**ZONING MAP CHANGE
STAFF REPORT**

Site Location: 2001 E. 4th Street Mapsco: 63T

TOP GOLF FORT WORTH
CITY OF FORT WORTH
TARRANT COUNTY, TEXAS

ZONING CASE No. ZC-15-133

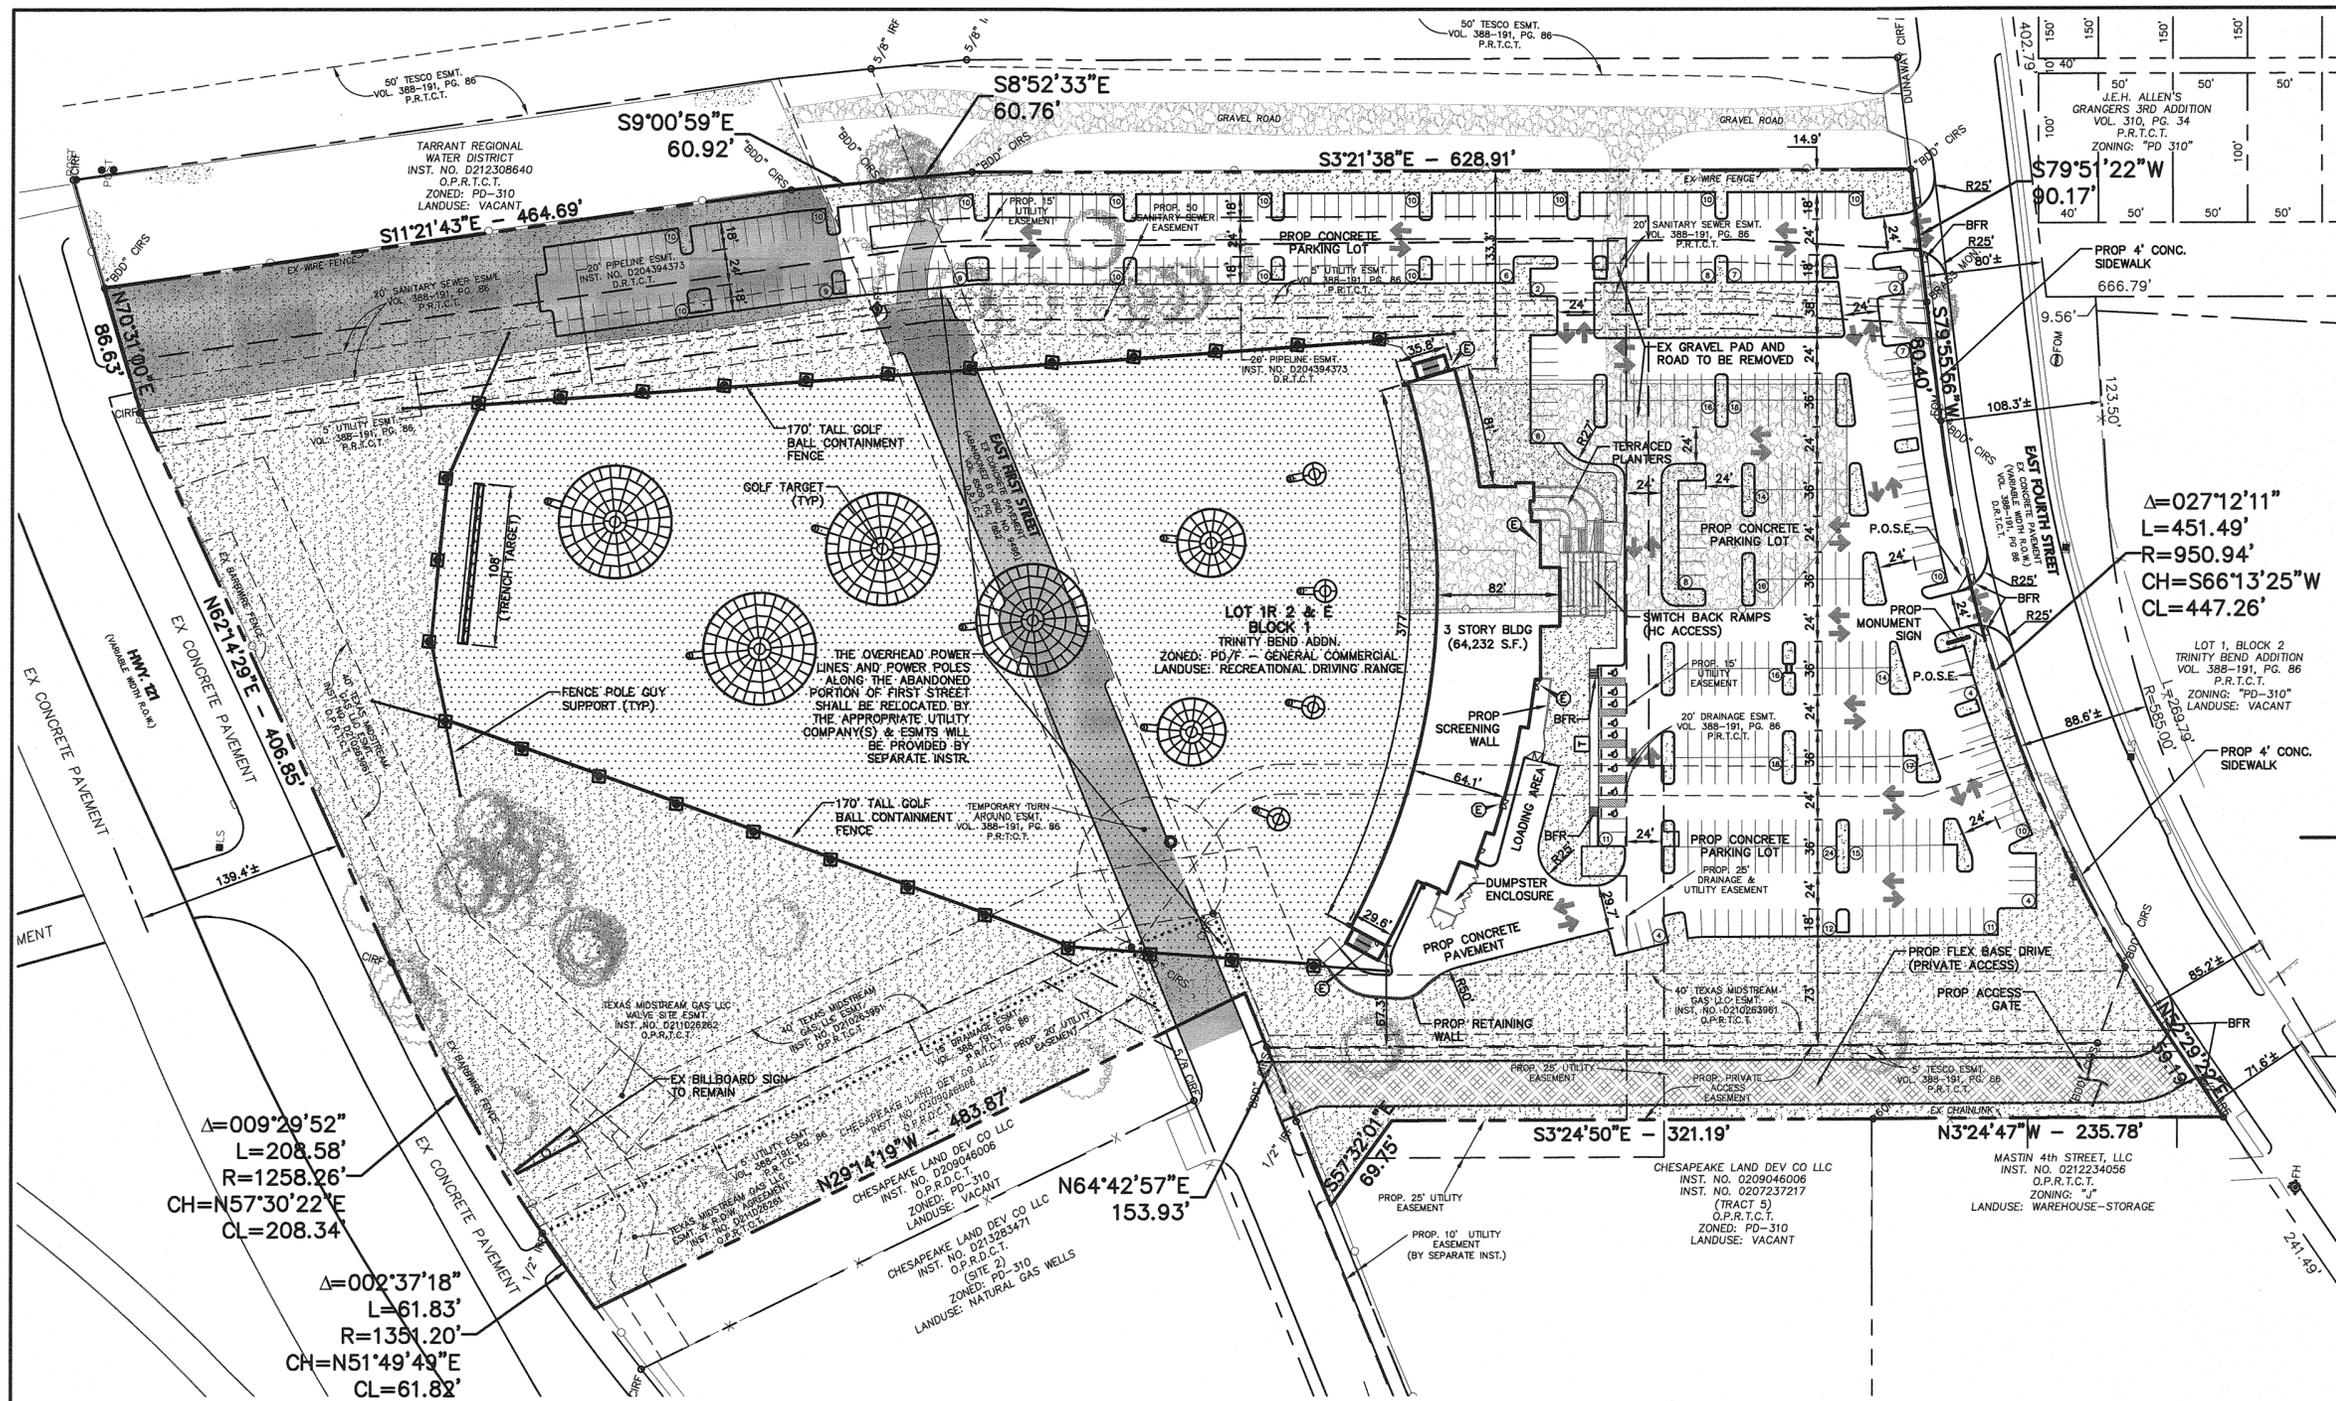
The site plan as submitted is not in general compliance with the zoning regulations. The key deficiencies are:

1. The site plan indicates 170 ft. netting for poles, maximum height is 45 ft. **(waiver required)**
2. The attached signage exceeds the maximum requirement. They are proposing 812 sq. ft. of aggregate area and 1,658 sq. ft. maximum overall attached signage. **(waiver required)**
3. The maximum height for monument signs is 8 ft. The site plan diagram indicates 9’ 5 ½”. **(waiver required)**

1. Driveway Locations - Driveway location must not interfere with intersection function. The proposed easternmost driveway does not provide sufficient spacing between it and the adjacent gravel road driveway serving the Tarrant Regional Water District site adjacent to the development.

2. Variable ROW - Show the full ROW widths for all existing streets. For streets having variable ROW, call out the ROW as "Variable" and give "Range" of the ROW.

3. Freeway ROW - Call out all freeway ROW. Show distance from property line to centerline of freeway. For a freeway having a variable ROW, call out the ROW as "Variable" and give the "Range" of the ROW. TXDOT approval required for any proposed interchanges and/or driveway access to TXDOT facilities. Access to SH 121 shall be reviewed and approved by TXDOT.

4. Sidewalks - Sidewalks and street lights are required for all public and private streets and public access easements as per City of Fort Worth Standards

1. PRV's, pressure reducing valves required due to high pressure
2. Field verify 68-inch sewer main M-245B
3. 25 foot easement for water and sanitary sewer on eastside of subject property line, between 1st street and 4th street.
4. Pressure guaranteed at ground elevation
5. Extend sewer
6. No permanent structures over, under, encroaching water/sewer lines and their easements, including trees
7. Reroute water line (refer to PDC 12/22/2014)
8. Grease trap required for commercial Kitchen, coordinate with Pre-Treatment ---> Alphonse Newton

Zoning Commission recommended waivers to the items noted above.
